Access Compliance Report

Public Rights-of-Way

| Intersection ID: 3015 | Main Street: FOX_TROT_DR | Cross Street: GLENSTONE_CT | Location: SE |
| ADA ID: 1748D5253575 | Ramp Type: Perp | Initial Pass/Fail: Pass | Overall Compliance: No |

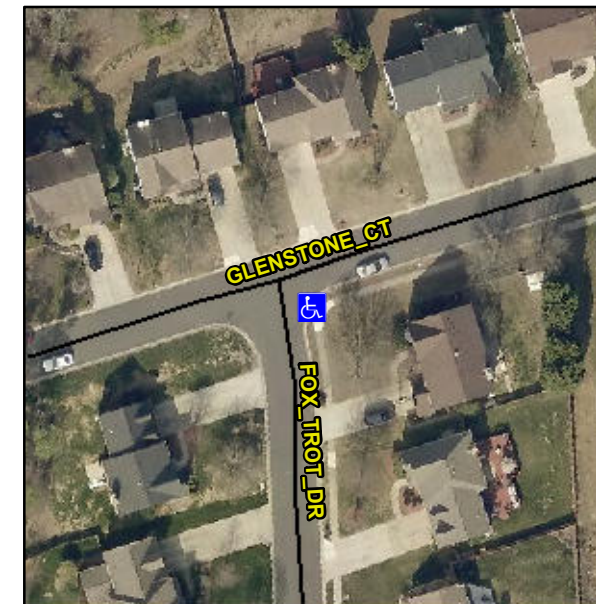
Not Found, R305.2

| Compliance | Description | Data | Compliance | Description | Data |
|------------|-----------------------|--------|------------|-----------------------------|------|
| N/A | Landing Curb? (Y/N) | No | No | DWS Offset (in) | 2.3 |

Remove & Replace Entire Ramp.
